ASEP IWG Report to GRB 65th

Presentation of ECE/TRANS/WP.29/GRB/2017/2 -
(IWG on ASEP) Proposal for Supplement 2 to the 03
series of amendments to Regulation
and GRB-65-26

1.2

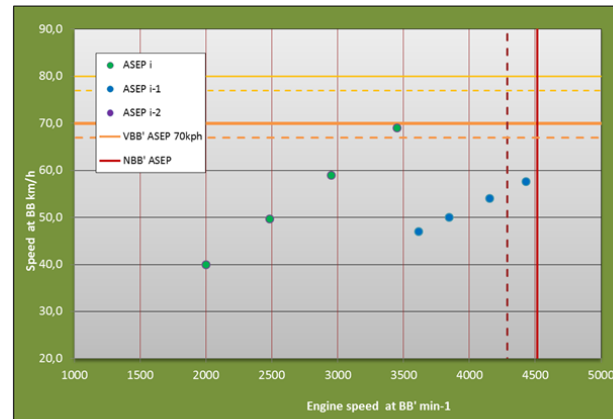
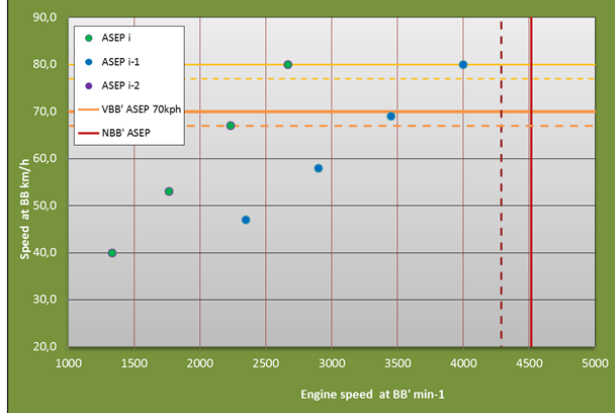
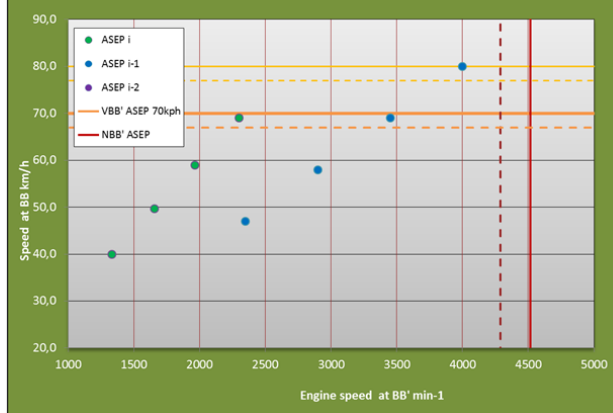
1.2. The ambiguous principle of target speed 70 or 80 km/h was replaced by:

- (a) 80 km/h target speed (depending on n_{BB_ASEP}) for locked transmission for the lowest valid gear and non-locked transmission, to make sure that, at the lowest gear, the vehicle is tested closest to the requested maximum engine speed;
- (b) 70 km/h target speed was considered for all gears other than the lowest, as none of the higher gears can provide the maximum engine speeds higher than those achieved in the lowest gear.

Same Speed
and engine
speed range

Reduced
speed range
(until
10km/h)
Same engine
range

1.4

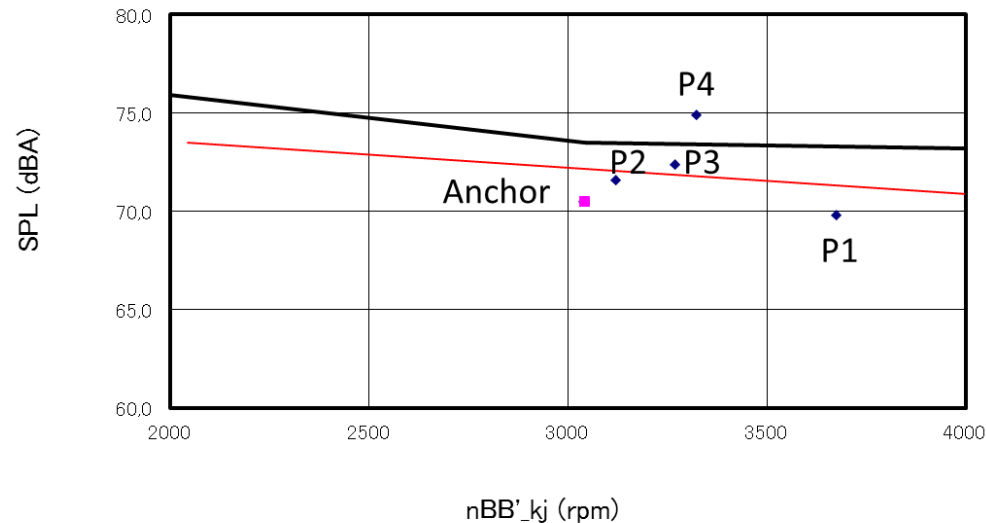
1.4. For the slope assessment, the "slope_k < 0 on non-locked automatic transmission, the selected transmission setup not valid" was enhanced by the provision that, in this case, the L_{urban} - assessment shall be used. Otherwise, it would not be clear what should happen in this situation.
